BALTIMORE GAS AND ELECTRIC COMPANY

Subject: Calvert Cliffs Nuclear Power Plant  
Units Nos. 1 & 2, Dockets Nos. 50-317 & 50-318  
Partial-Loop Operation

RESPONSE TO NRC DATA REQUEST

FIGURE 1

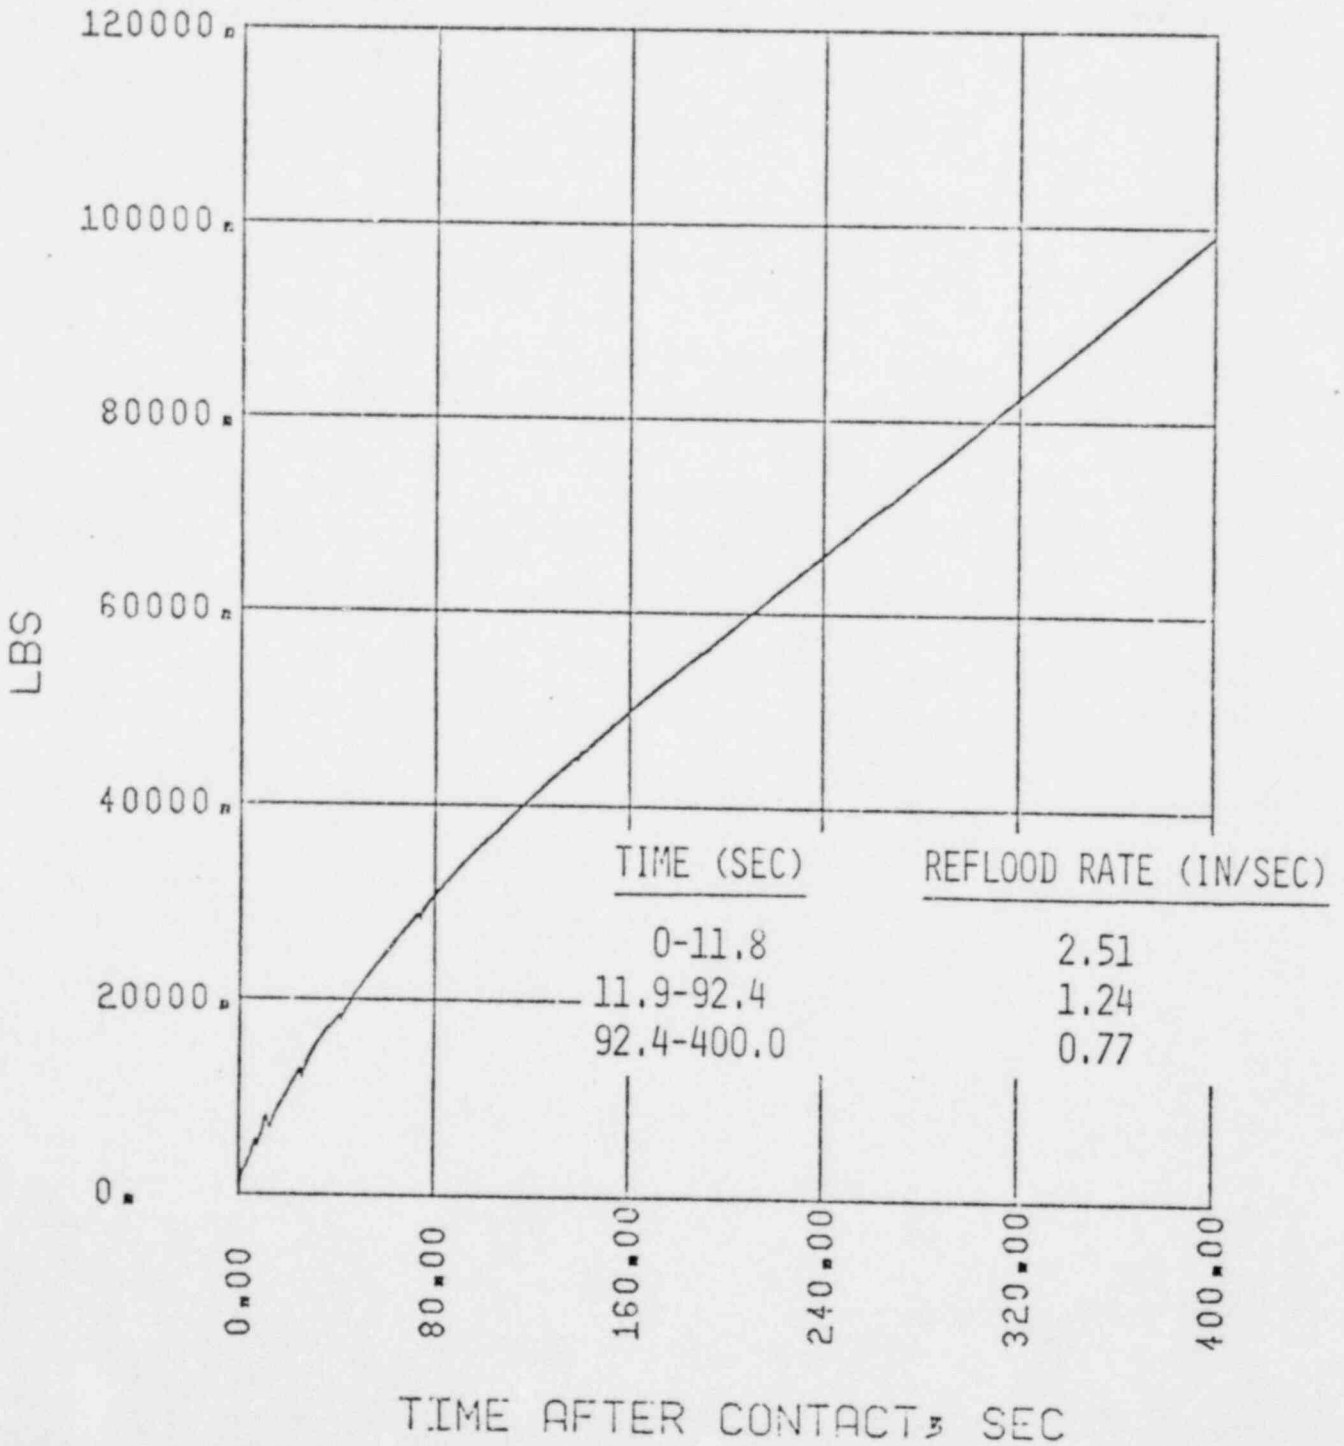
- a. the hot pin axial power profile
- b. the power decay curve in tabular form
- c. the time varying inlet core reflood rate in plot form
- d. the time varying core outlet mass flow in plot form
- e. and, the time varying core mixture level in plot form."

The time varying reflood rate, outlet mass flow, and mixture level are given in Figures 1, 2 and 3, respectively.
